72+COLLINS HOTEL & CONDOMINIUM

CITY OF MIAMI BEACH DESIGN REVIEW BOARD

FEBRUARY 2, 2021

ELEVATION EAST CORNER FACADE - PHASE 2

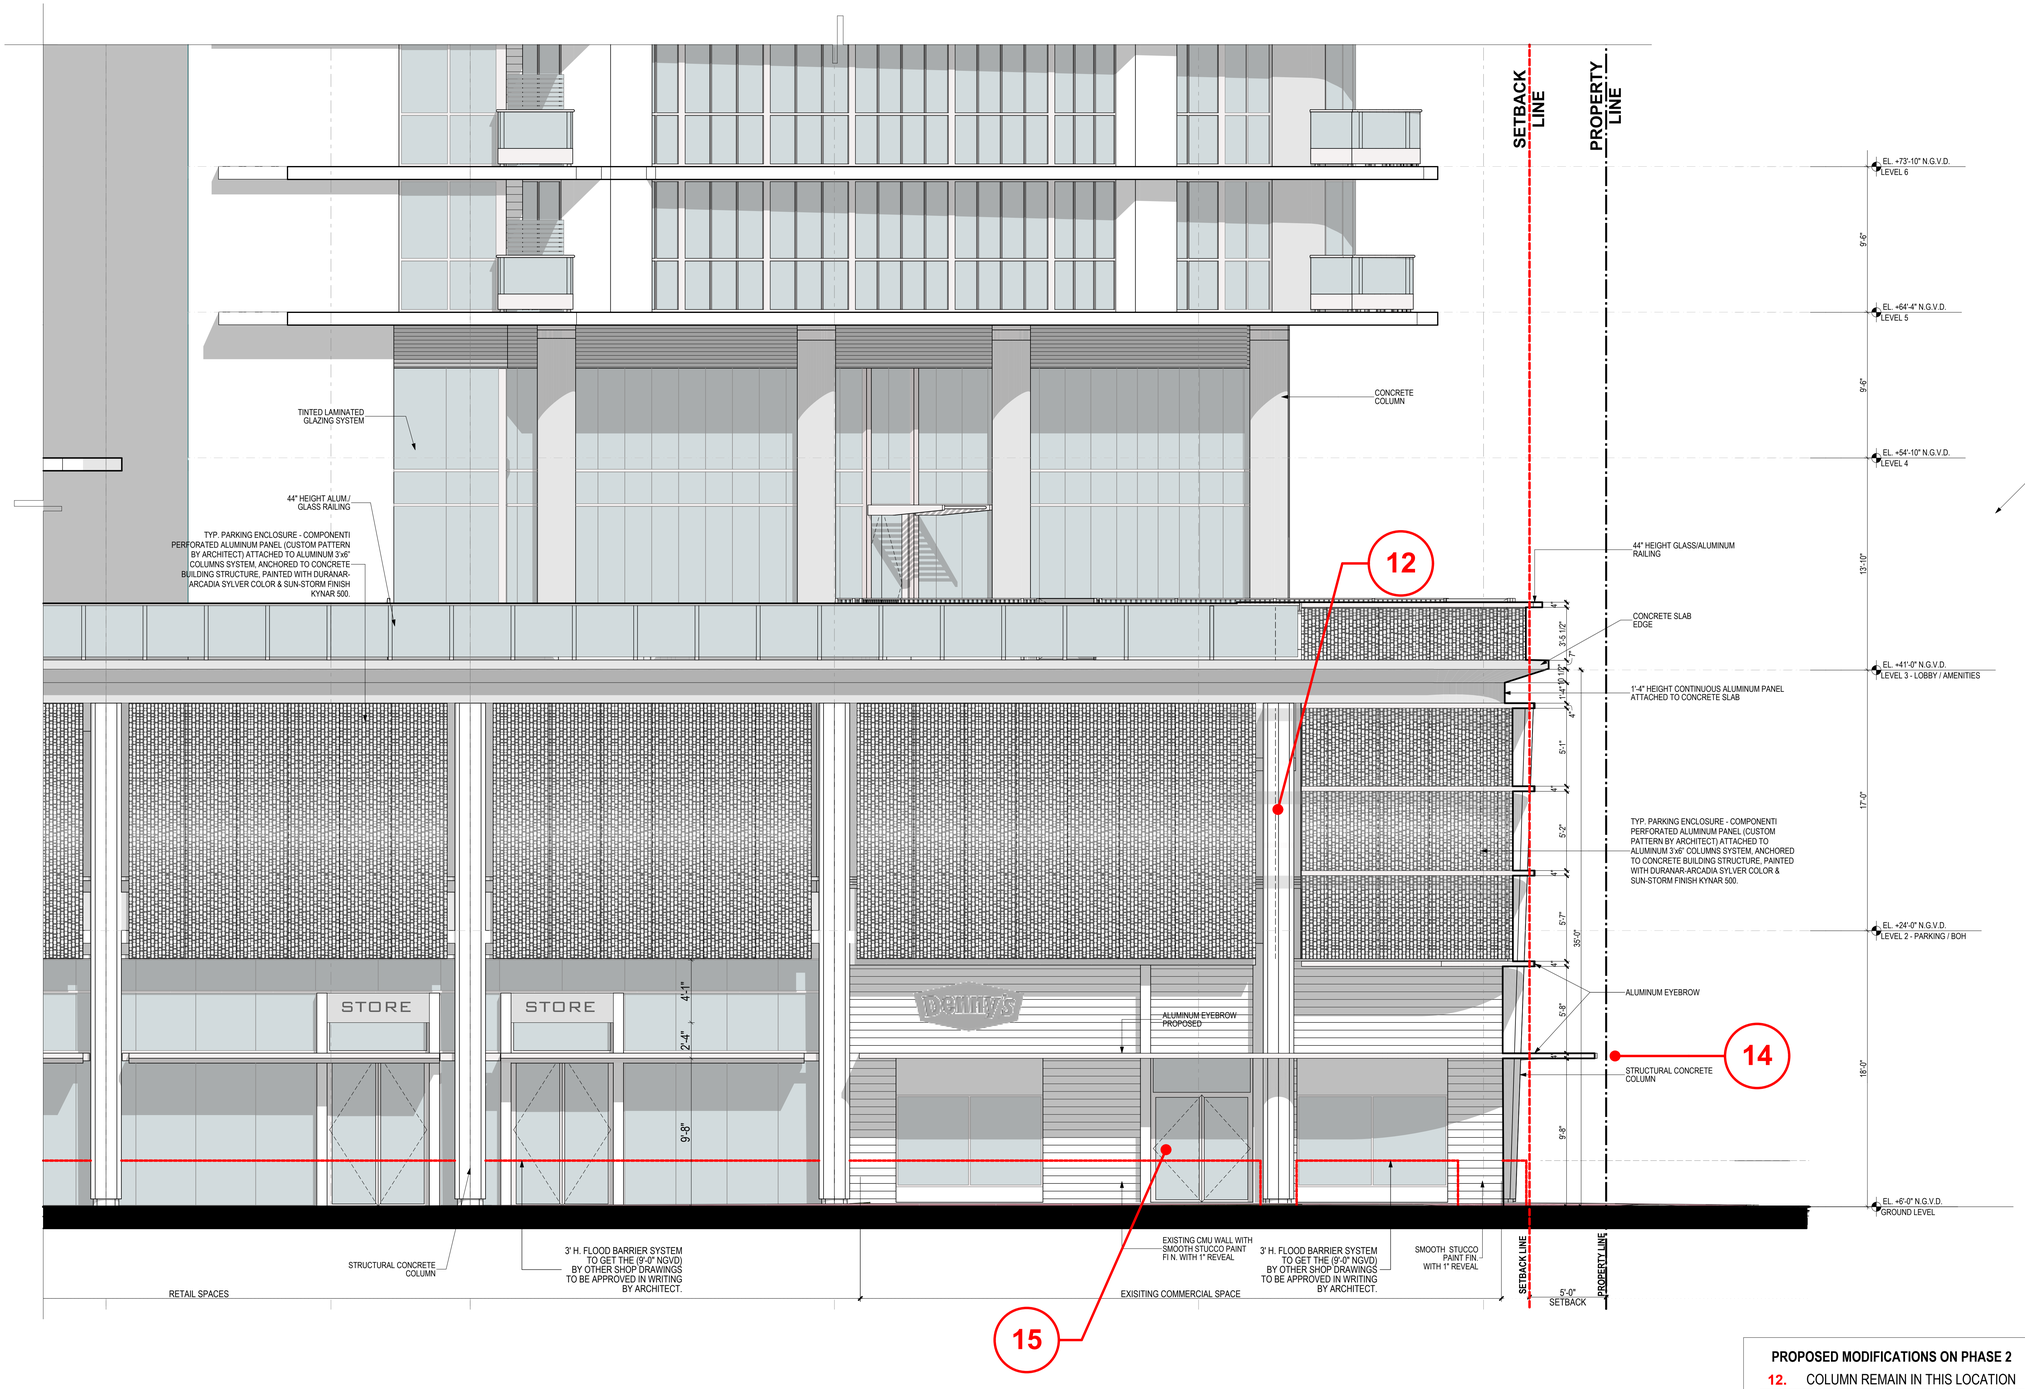
PROPOSED MODIFICATIONS ON PHASE 2

12.	COLUMN REMAIN IN THIS LOCATION
14.	ALUMINUM AWNING/EYEBROW DIMENSIONS REMAIN
15.	RELOCATION RETAIL DOOR

PARTIAL SECTIONS - ADDITIONAL PARKING

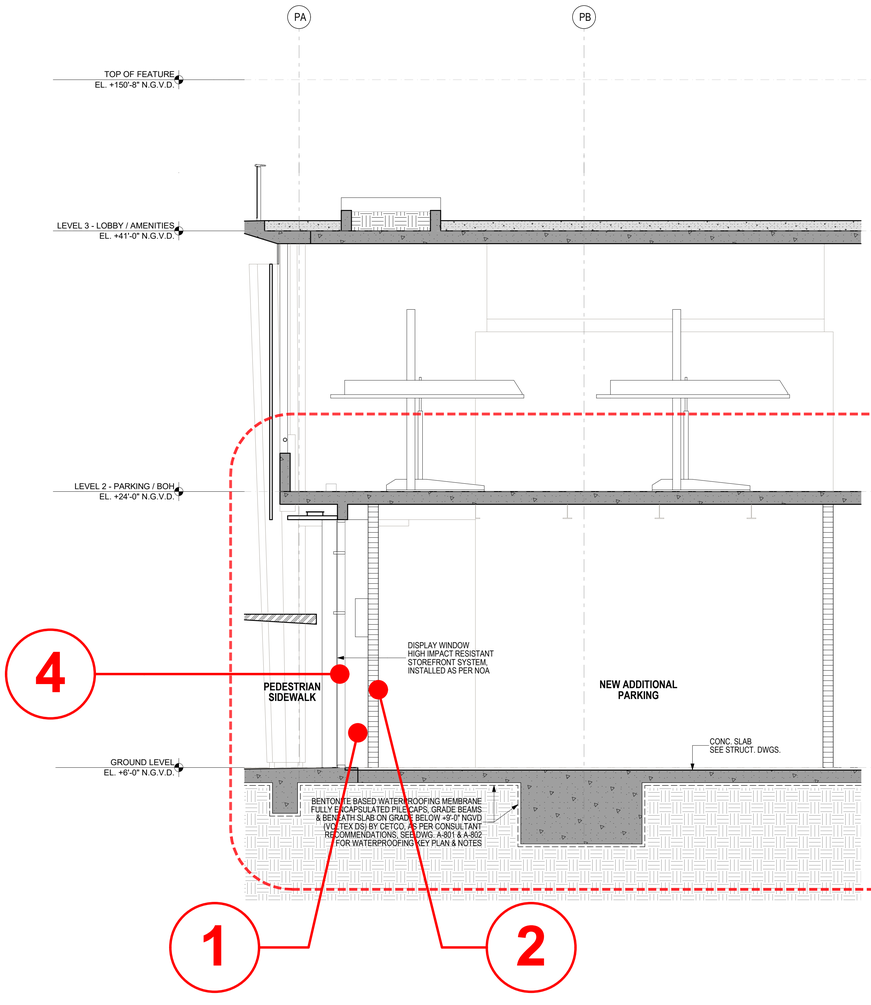
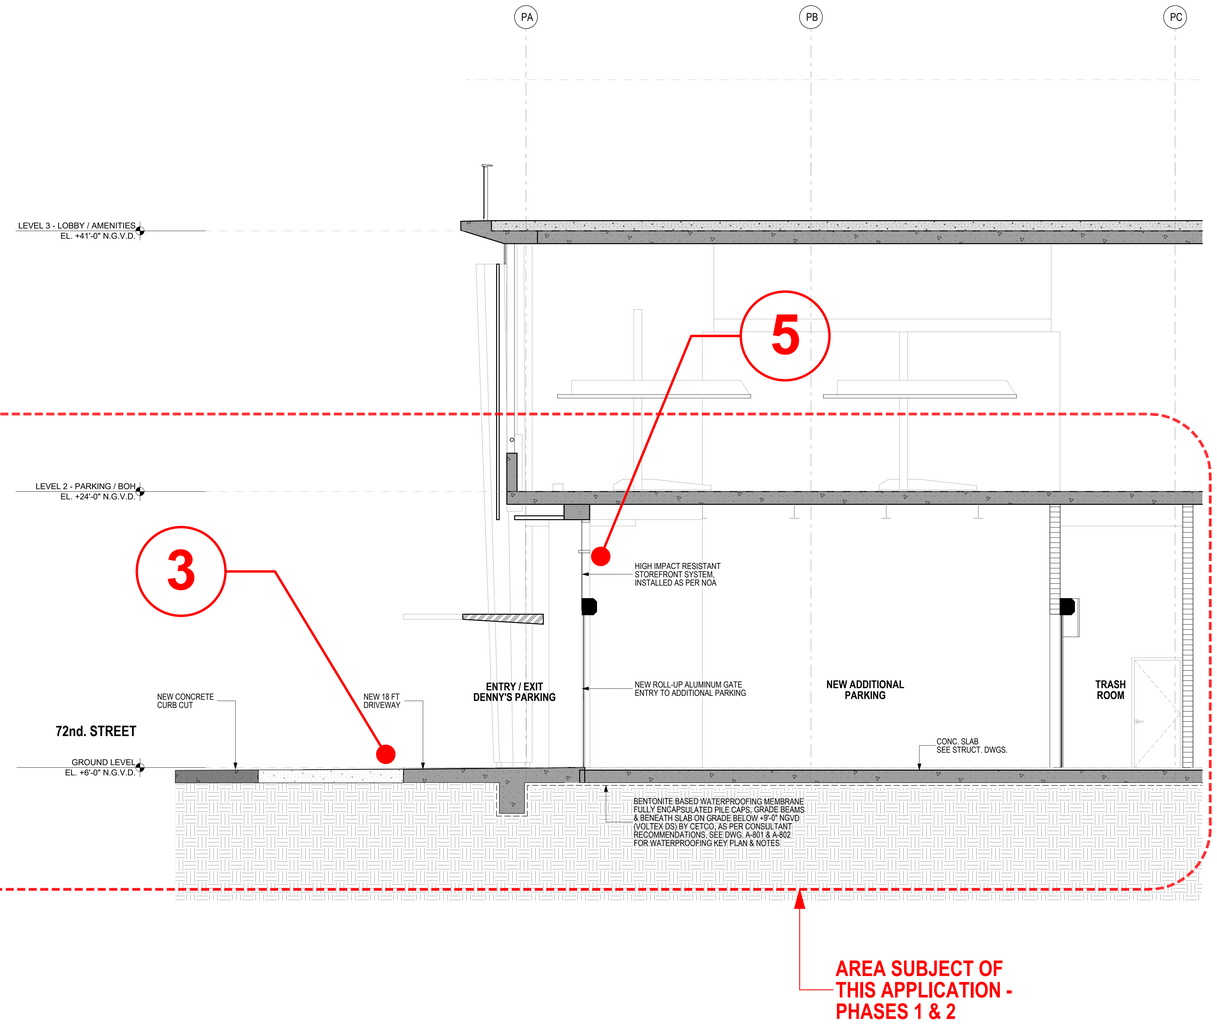
1. SEC. 142-745 (e)(2)(b). EXCEPT WHERE REQUIRED FOR DRIVEWAYS AND UTILITY INFRASTRUCTURE, THE GROUND FLOOR SHALL CONTAIN HABITABLE SPACE WITH A MINIMUM DEPTH OF 50 FEET FROM BUILDING FACADE. **2 FT PROVIDED.**

4. SEC. 142-745 (a)(8)(b). FRONTAGE FOR COMMERCIAL, HOTEL, AND ACCESS TO UPPER LEVEL FRONTAGE SHALL CONTAIN A MINIMUM OF 70 PERCENT CLEAR GLASS WINDOWS WITH VIEWS INTO HABITABLE SPACE. **21.56 % PROVIDED.**

2. SEC. 142-745 (e)(2)(e). GROUND FLOOR AND SURFACE PARKING SHALL SETBACK A MINIMUM OF 50 FEET FROM THE BUILDING FACADE AND BE CONCEALED FROM VIEW FROM THE CLEAR PEDESTRIAN PATH. **2 FEET PROVIDED.**

5. SEC. 142-745 (a)(10)(a). PARKING FACILITIES SHALL BE ENTIRELY SCREENED FROM VIEW FROM PUBLI RIGHTS-OF-WAY AND CLEAR PEDESTRIAN PATHS.

3. SEC. 142-745 (e)(3). DRIVEWAYS AND VEHICLE ACCESS TO OFF-STREET PARKING AND LOADING SHALL BE PROHIBITED ON CLASS A FRONTAGE, UNLESS IT IS THE ONLY MEANS OF EGRESS TO THE SITE. **ONE DRIVEWAY PROVIDED ON 72 STREET, WHIS IS A CLASS A FRONTAGE.**
